APPLICATION NO.	FILING DATE	FIRST NAMED INVENTOR	ATTORNEY DOCKET NO.	CONFIRMATION NO
10/000,276	11/02/2001	Spencer W. Beaufore	OPME / 05	8989
26875	7590 04/05/2005		EXAM	INER
WOOD, HERRON & EVANS, LLP			BOGART, MICHAEL G	
2700 CAREW TOWER 441 VINE STREET			ART UNIT	PAPER NUMBER
CINCINNATI, OH 45202			3761.

Application No.	Applicant(s)				
	10/000,276	BEAUFORE ET AL.				
Office Action Summary	Examiner	Art Unit				
	Michael G. Bogart	3761				
The MAILING DATE of this communication apperiod for Reply	ppears on the cover sheet with th	e correspondence address				
A SHORTENED STATUTORY PERIOD FOR REP THE MAILING DATE OF THIS COMMUNICATION - Extensions of time may be available under the provisions of 37 CFR 1 after SIX (6) MONTHS from the mailing date of this communication. - If the period for reply specified above is less than thirty (30) days, a re If NO period for reply is specified above, the maximum statutory perio - Failure to reply within the set or extended period for reply will, by statu Any reply received by the Office later than three months after the mail earned patent term adjustment. See 37 CFR 1.704(b).	1. 1.136(a). In no event, however, may a reply be eply within the sta

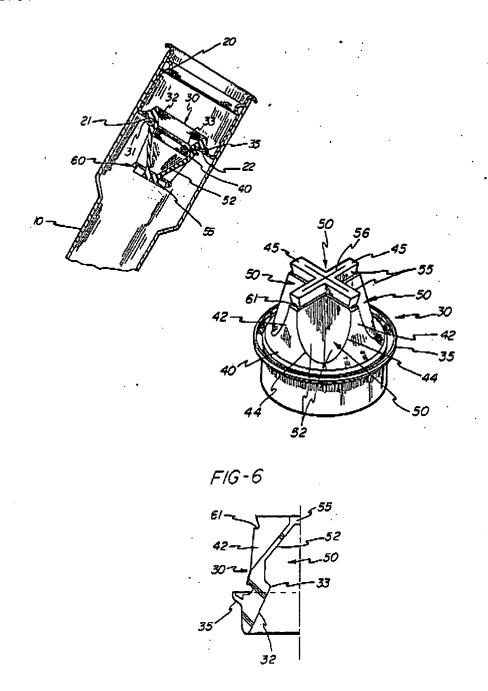
Claims 44, 48 and 49 are rejected under 35 U.S.C. § 102(b) as being anticipated by Boehmer et al. (US 4,924,923).

Regarding claim 44, Boehmer et al. teach a flow control valve comprising:

a valve member (30) having a normally closed inlet orifice (56); and

a crush limiting member (55) associated with said valve member (col. 3, lines 28-52)(see figs. 2, 4 and 6, below).

Regarding the crush limiting member or rim (55), it is noted that it is of greater thickness which forms a stiffer rim. This construction makes it more resistant to crushing by external forces applied to the valve (30).

Regarding claim 48, Boehmer et al. teach at least one single slit (56).

Regarding claim 49, Boehmer et al. teach a double duckbill valve (fig. 4).

F1G. 10

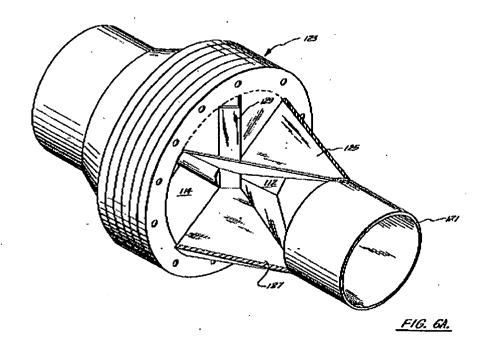
Claim 67 is rejected under 35 U.S.C. § 102(b) as being anticipated by Soucy (US 3,387,624).

Soucy teaches a catheter-like tube (1) comprising:

said liquid flow control valve being a double-duckbill valve;

said double-duckbill valve having an inlet orifice (10) operable to control liquid flow therethrough; and

an elastomeric band (11, 12) disposed about said double-duckbill valve and operable to urge said inlet orifice to a closed position (fig. 10).

Regarding the claimed limitation of the device being a urinary catheter, there are no limitations in the claim that positively distinguish this physical structure from a simple tube.
